To: T10 Technical Committee  
 From: Rob Elliott ([elliott@hp.com](mailto:elliott@hp.com)) and Thomas Grieff ([thomas.grieff@hp.com](mailto:thomas.grieff@hp.com)), HP  
 Date: 18 July 2002  
 Subject: T10/02-198r6 SAS OOB timing

### **Overview**

The OOB timing requirements need to be more precise, listing the transmit burst time and specifying receiver tolerances. Various other minor changes are also included.

Figure 1. **Phy reset sequence OOB signal generation transmission and detection**

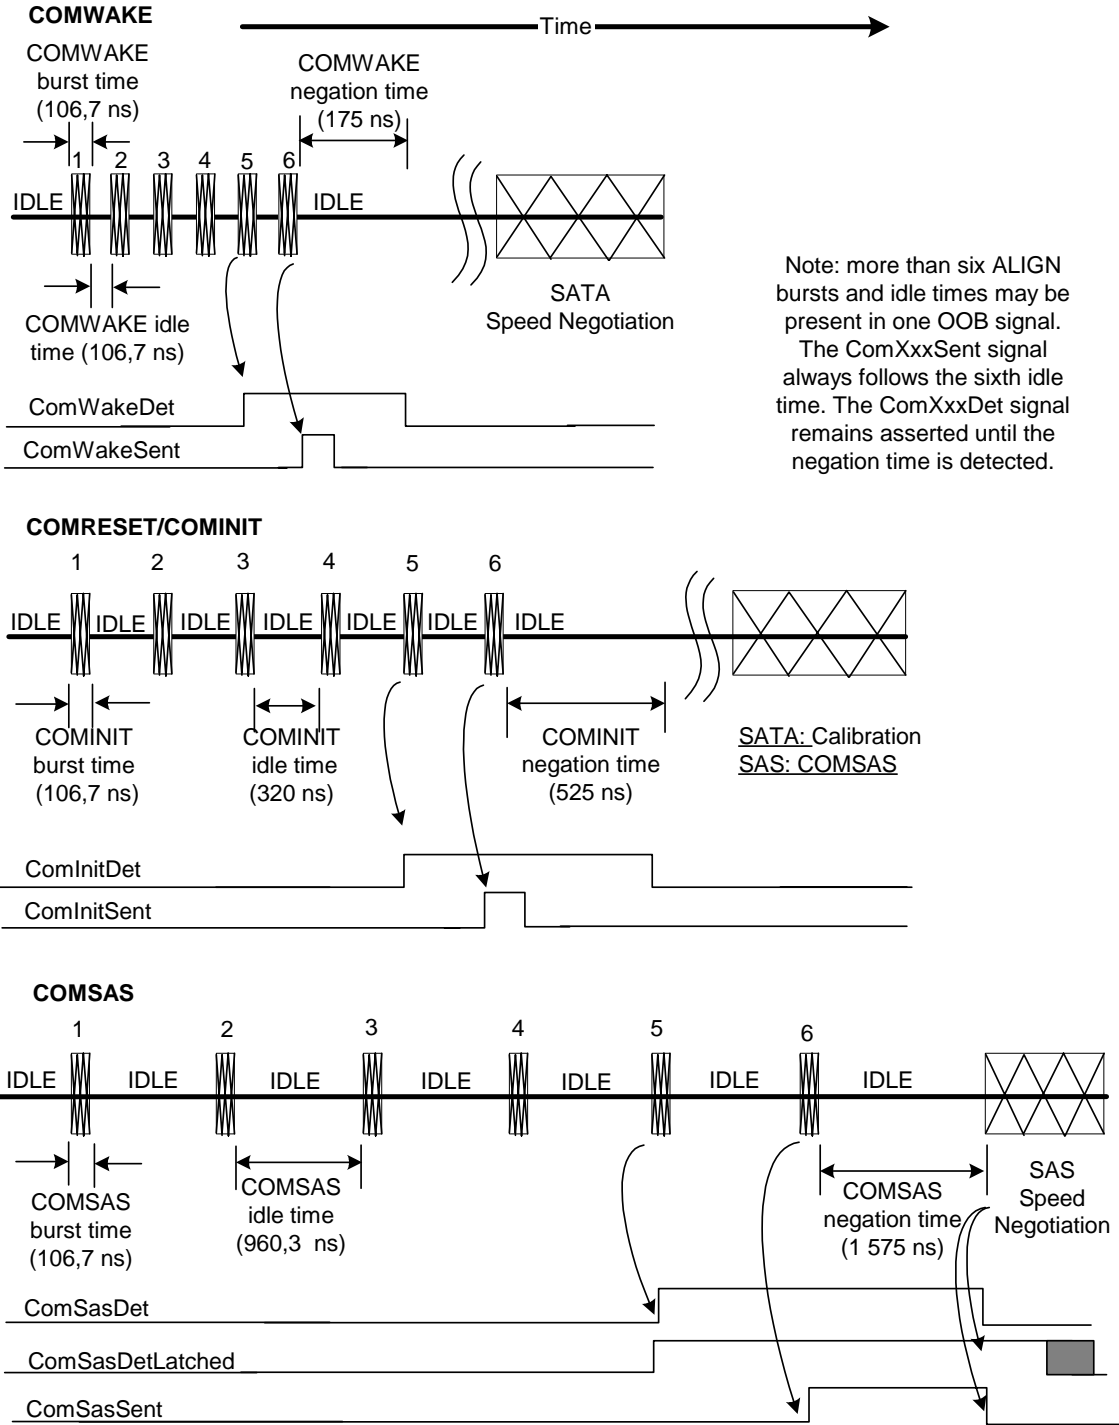
Figure 1 illustrates the timing required for the generation and detection of all the SAS OOB signals. The signals labeled ComXxxDet and ComXxxSent (where Xxx is Wake, Init, or Sas), are inputs to the SAS phy Initialization layer state machine. ComXxxDet is an output from the OOB detection circuitry that indicates the detection of an incoming COMINIT, COMWAKE, or COMSAS sequencesignal. ComXxxSent is an output from the OOB generation circuitry that indicates that a burst-of-six COMWAKE, COMINIT, or COMSAS sequences-signal has been output onto the link.

The ALIGNs used in OOB sequences-signalling-signals are not required to be at generation 1 (G1) rates (1,5 Gbps), as this rate might not be supported in future generations of SAS devices. The ALIGNs are only required to generate an envelope for the detection circuitry, as required for any signaling that may be AC coupled. If G2 ALIGNs are used, the number of ALIGNs doubles compared with G1 ALIGNs. Likewise tTheThe idle time for

A SAS transmitter should ~~send OOB sequences with use~~ ALIGNs at the G1 rate ~~to create the burst portion of the OOB signal~~, but may ~~send them use~~ ALIGNs at its slowest supported rate ~~if it does not support the G1 rate~~ and shall not send them at a rate faster than its slowest supported rates.

A SAS receiver shall detect OOB ~~sequences signals~~ comprised of ALIGNs transmitted at any rate up to its highest supported rate. This includes rates below its lowest supported rates.

**Figure 36. SAS-to-SAS phy reset sequence**

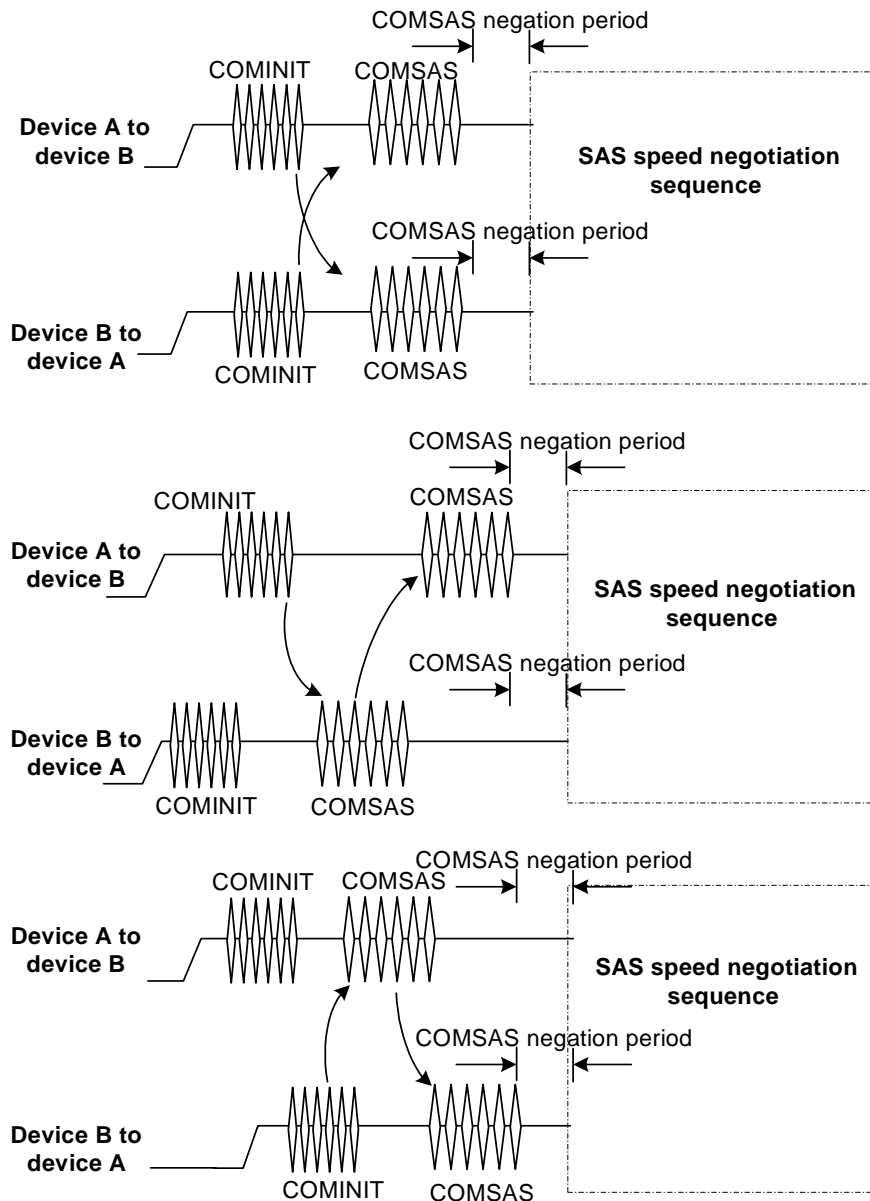
A SAS device shall distinguish between COMINIT and COMSAS and continue with a SAS speed negotiation sequence rather than the SAS reset sequence.

Figure 36 illustrates several different power-up sequences based on whether one a SAS phy powers up before, after, or at the same time as the SAS phy to which it is attached.

**Figure 2. Speed Negotiation Window**

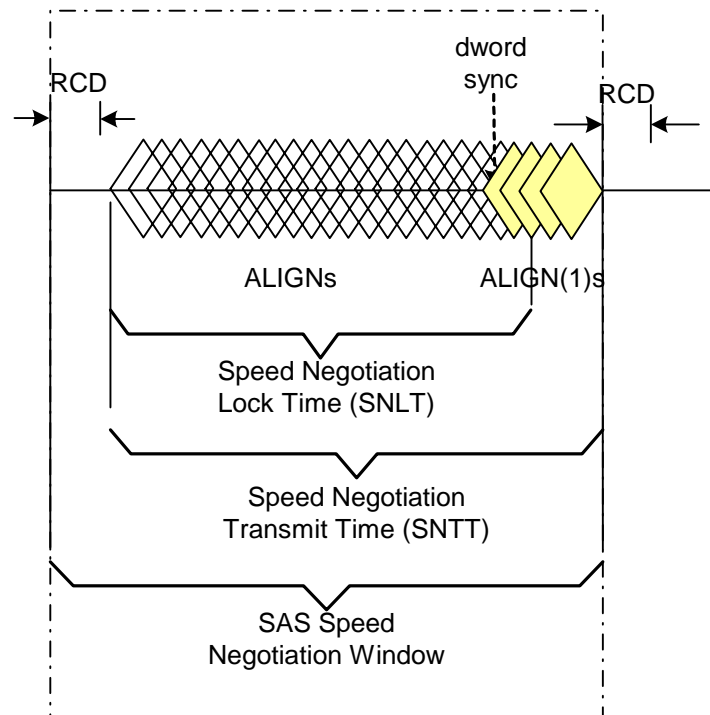
First, each device shall transmit IDLEside stop transmitting for a Rate Change Delay. Then, each device shall start transmitting ALIGNs at that link rate if it supports the link rate or shall transmit nothing IDLEside for the entire Speed Negotiation Window if it does not support the link rate.

In order to avoid mis-communication, where one device receives ALIGN1s and then starts transmitting them, but it is too late for the original device to recognize, a Speed Negotiation Lock Time is specified. This provides a safeguard against this occurrence. Since the Speed Negotiation Window is only as accurate as the detection of the COMSAS negation, there will always be some discrepancy on when SAS devices start and finish the speed negotiation process. Dword lock and the ALIGN1 handshake completion must be obtained sufficiently before the

If the device supports the link rate, it shall attempt to synchronize on an incoming series of dwords at the same rate for the Speed Negotiation Lock Time. The incoming dwords may be ALIGNs or ALIGN(1)s. If the device achieves dword synchronization within the Speed Negotiation Lock Time, it shall change from transmitting ALIGNs to transmitting ALIGN(1)s for the remainder of the Speed Negotiation Transmit Time (i.e., the remainder of the Speed Negotiation Window). If the device does not achieve dword synchronization within the Speed Negotiation Lock Time, it shall continue transmitting ALIGNs for the remainder of the Speed Negotiation Transmit Time. Figure xx illustrates the Speed Negotiation Window.

**Figure xx. SAS speed negotiation sequence (G1 only with G1 only)**

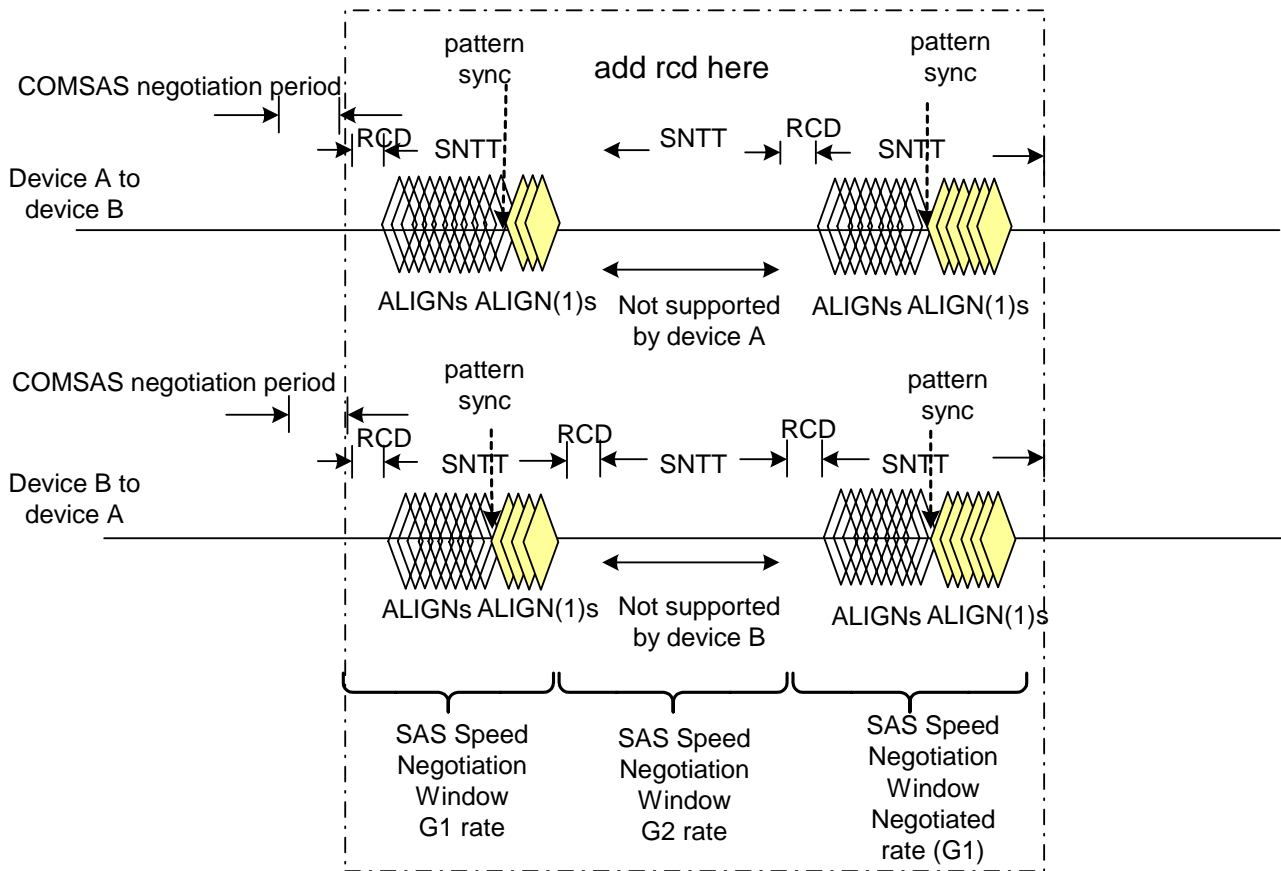
Figure xx shows a speed negotiation between a SAS device A that supports only the G1 link rate attached to a SAS device B that only supports the G1 link rate. They both run the G1 Speed Negotiation Window (valid) and the G2 Speed Negotiation Window (invalid), then select G1 for the final Speed Negotiation Window used to establish the negotiated rate.

Figure 37. SAS speed negotiation sequence (example 4-G1, G2, G3 with G1, G2)

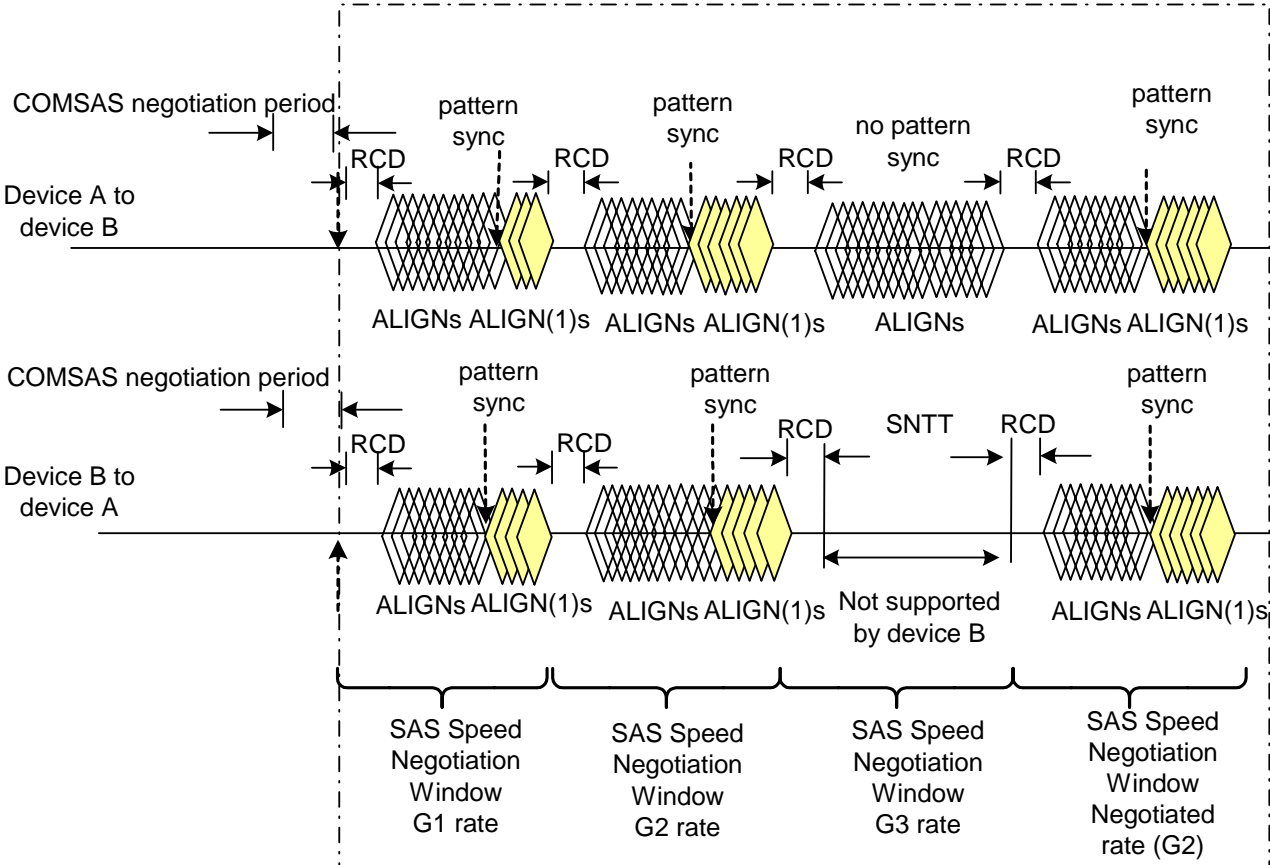
Figure 37 shows a speed negotiation between a SAS phy-device A that supports speeds-G1 thru G3 link rates attached to a SAS phy-device B that only supports speeds-G1 and G2 link rates. They both run the G1 Speed Negotiation Window (valid), the G2 Speed Negotiation Window (valid), and the G3 Speed Negotiation Window (supported by device A but not by device B, so invalid), then select G2 for the final Speed Negotiation Window used to establish the negotiated rate.

**Figure 38. SAS speed negotiation sequence (example-2G1, G2, G3 with G2 only)**

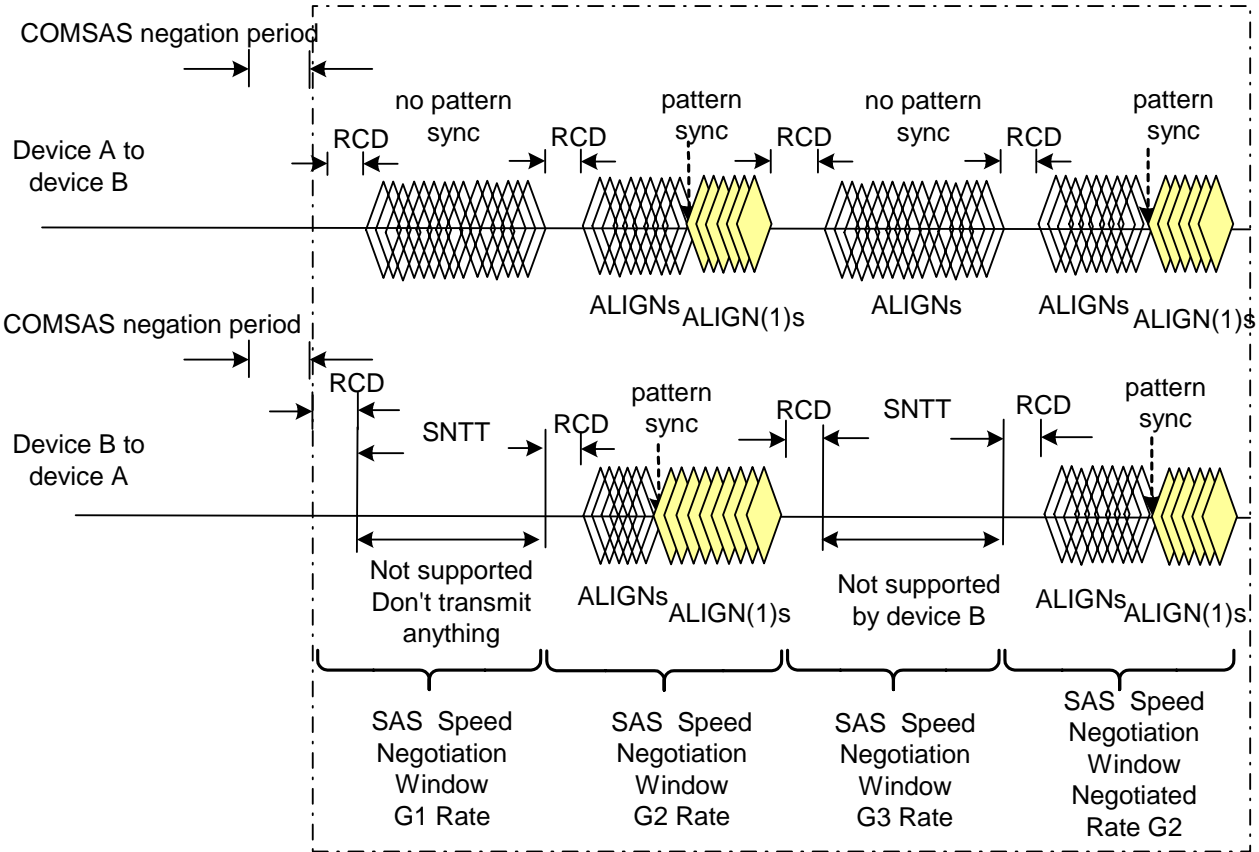
Figure 38 shows speed negotiation between a SAS device A that supports G1 thru G3 link rates and a SAS device B that only supports the G2 link rate. They both run the G1 Speed Negotiation Window (supported by device A but not by device B, so invalid), the G2 Speed Negotiation Window (valid), and the G3 Speed Negotiation Window (supported by device A but not by device B, so invalid), then select G2 for final Speed Negotiation Window to establish the negotiated rate.

Figure 39. SAS speed negotiation sequence (example 3G1,G2,G3 with G1,G2 and failure)

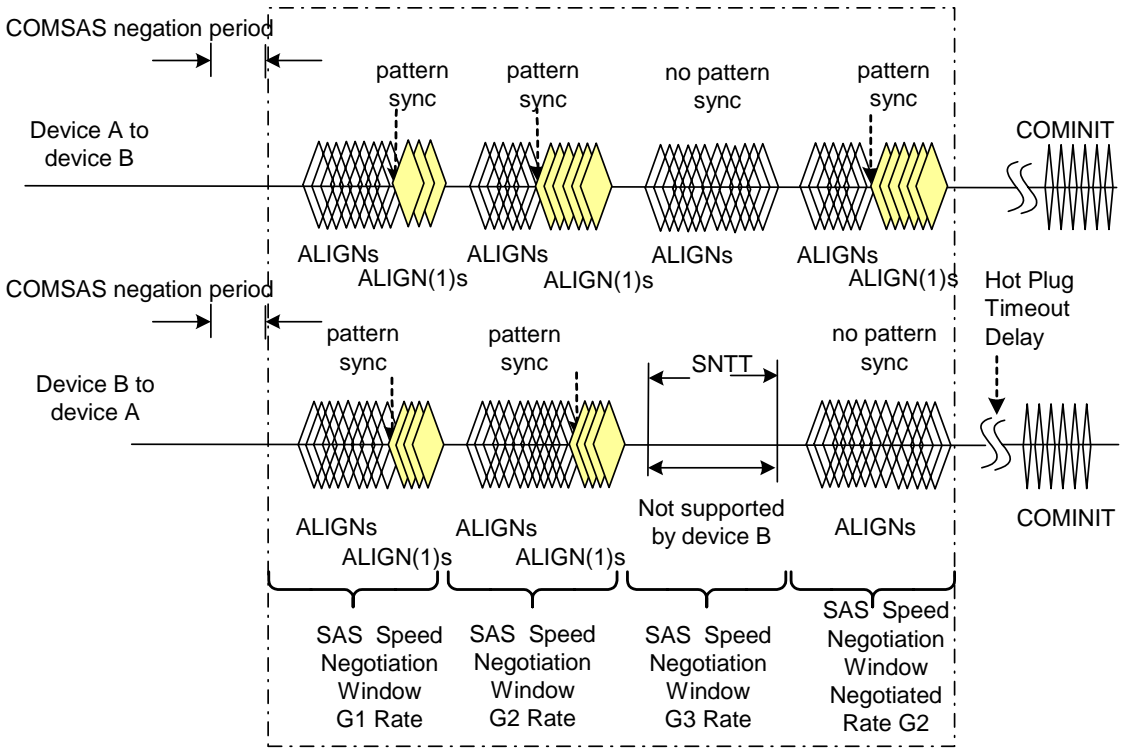
Figure 39 shows the same speed negotiation sequence as in Figure 37, except for some reason, one of the SAS device's PLLs does not obtain ~~pattern\_dword~~ synchronization and detect ~~ALIGNs~~ during the final speed negotiation window. If this occurs, the handshake is not complete and the OOB sequence shall be retried starting with COMINIT, forcing the ~~link-phy~~ to retry the whole reset sequence.

Any time a SAS phy fails speed negotiation, it shall wait the Hot Plug Time-out Delay before attempting a retry.
